DATE: DECEMBER 4, 2024
TO: ALL PLAN HOLDERS
FROM: PATSY STINSON
PROJECT: MONTGOMERY REGIONAL AIRPORT
MONTGOMERY, ALABAMA
AIRFIELD ELECTRICAL REPLACEMENT - PHASE II
GMC PROJECT NO.: TMGM210029(R)
RE: ADDENDUM #2

ADDENDUM NUMBER 2

MONTGOMERY REGIONAL AIRPORT MONTGOMERY, ALABAMA AIRFIELD ELECTRICAL REPLACEMENT - PHASE II GMC PROJECT NO.: TMGM210029(R)

II. Revisions to Plans

1
E21
AIRFIELD ELECTRICAL VAULT - ELECTRICAL PLAN
 SCALE: 1/2"=1'-0"

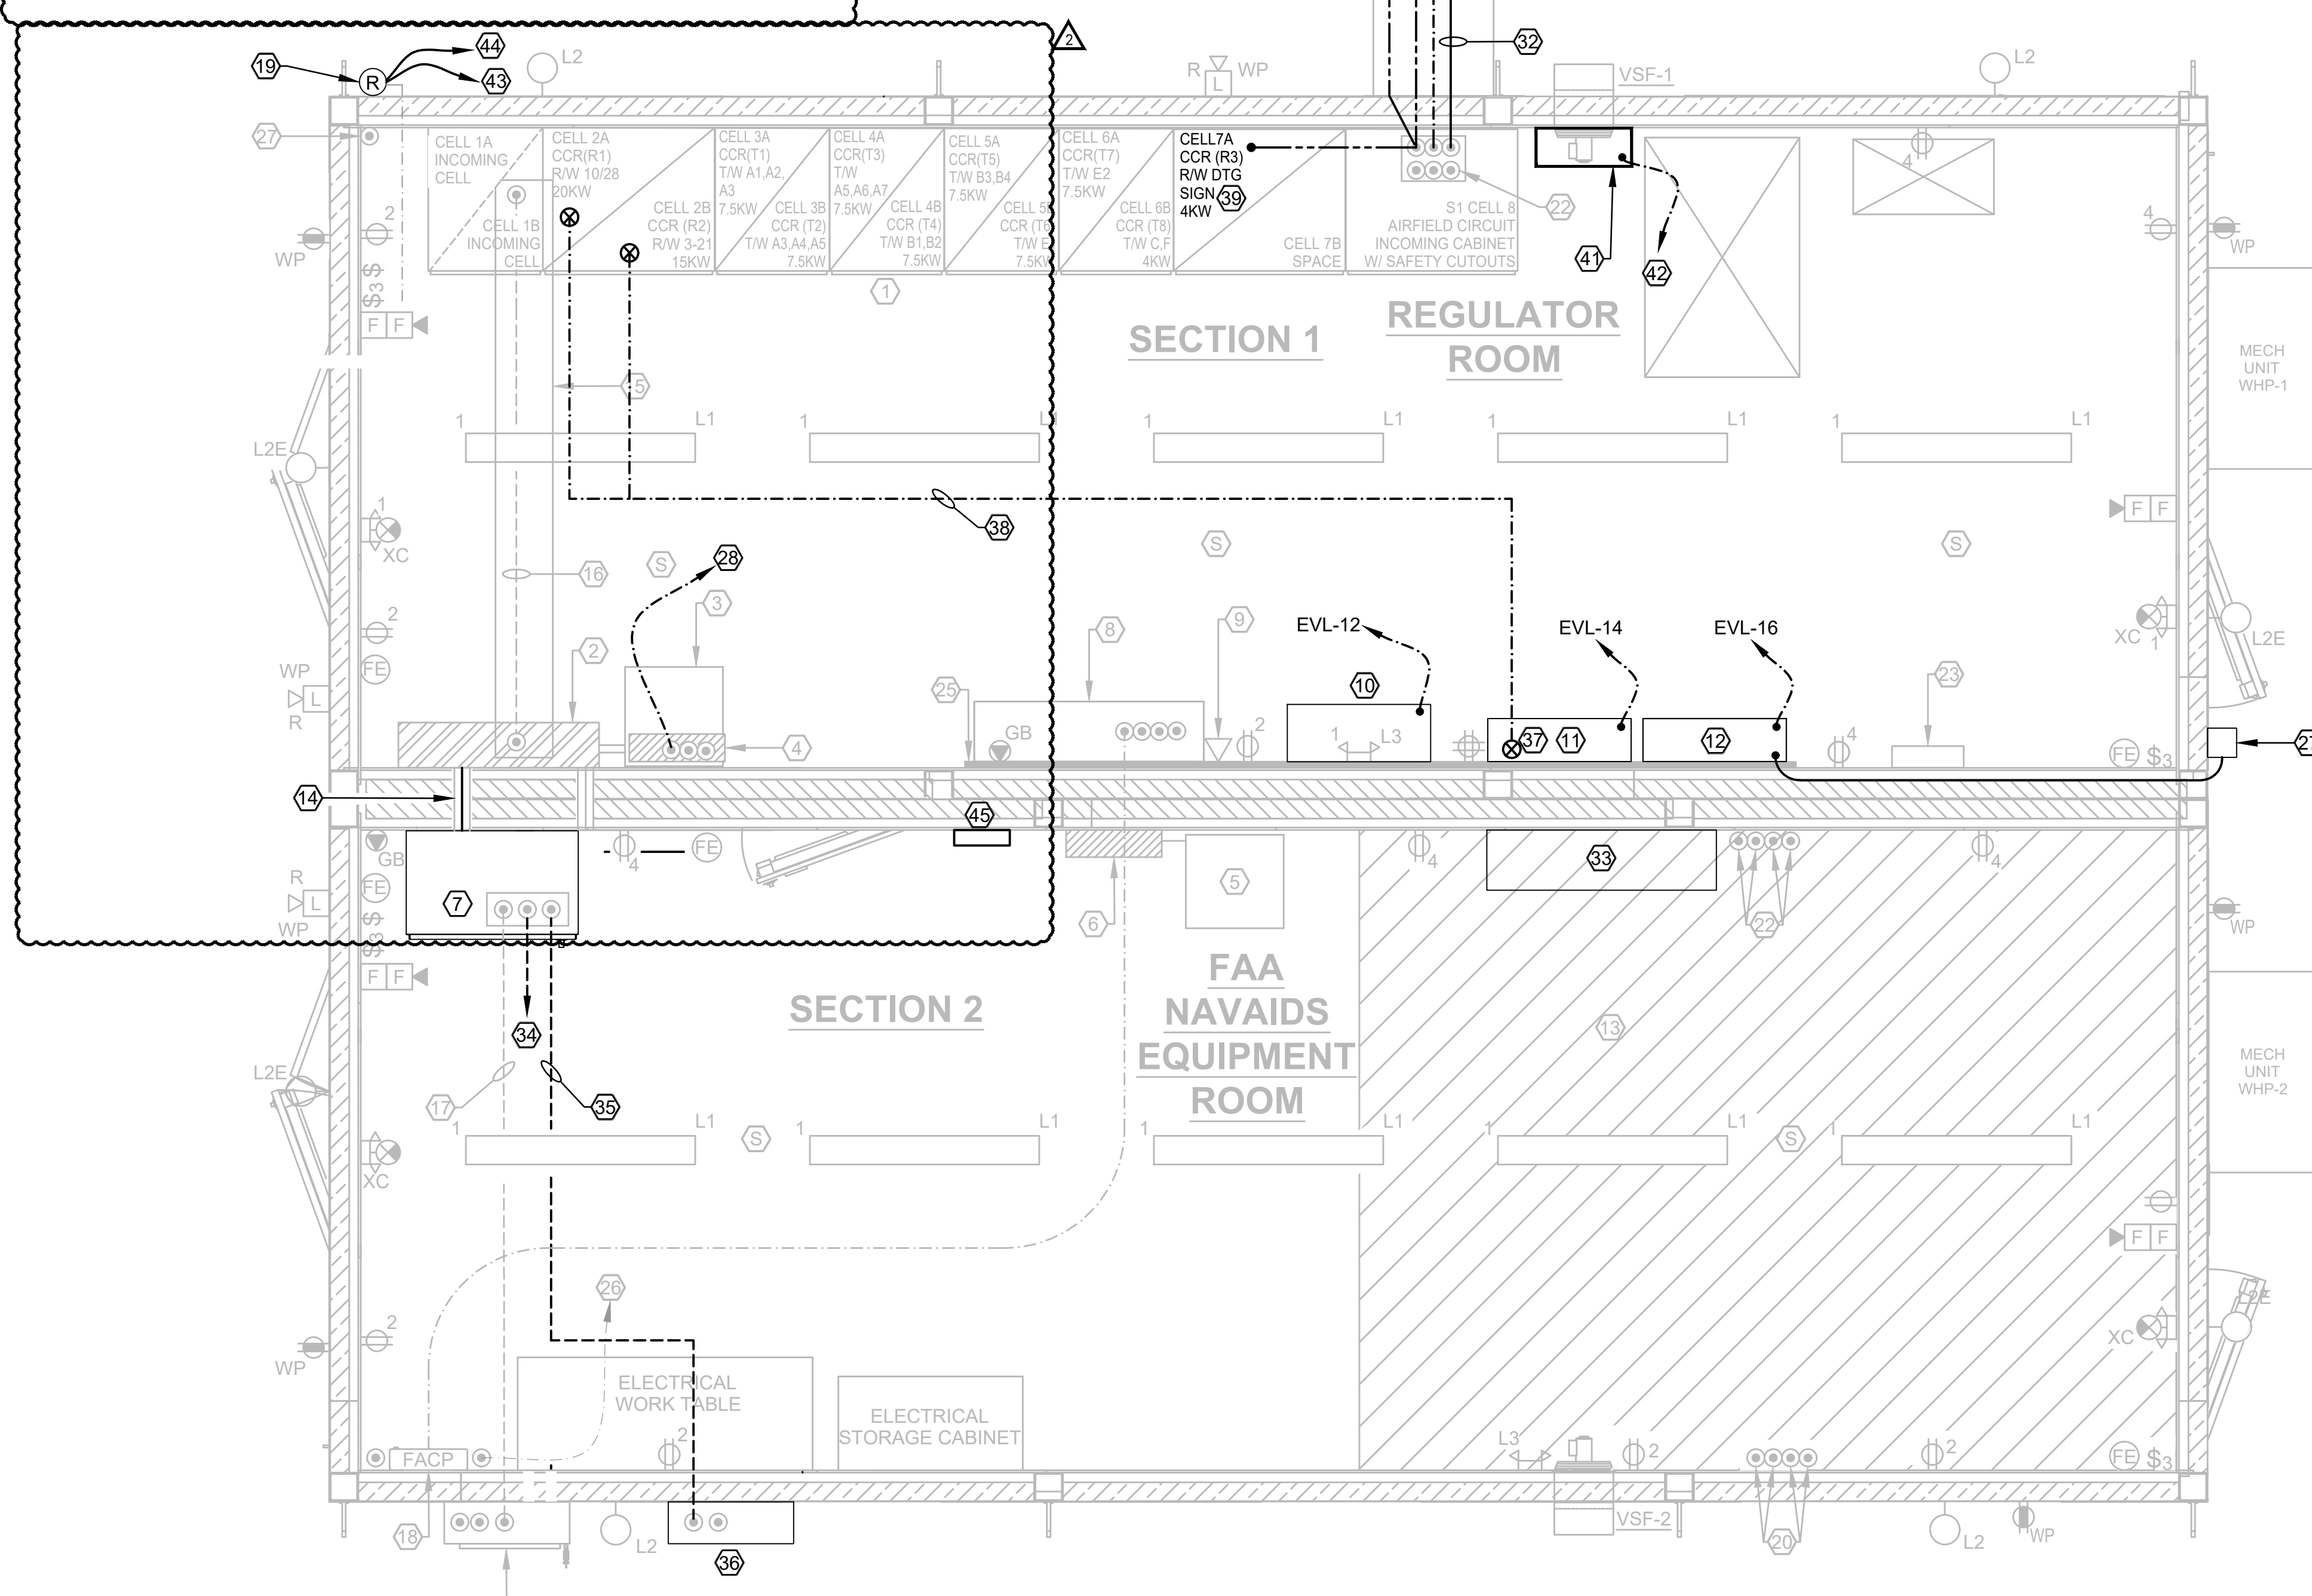
- A. See revised sheet E21 – Airfield Electrical Vault – Electrical Plan
- B. See revised sheet E33 – Typical Standby Generator System Ancillary Connections
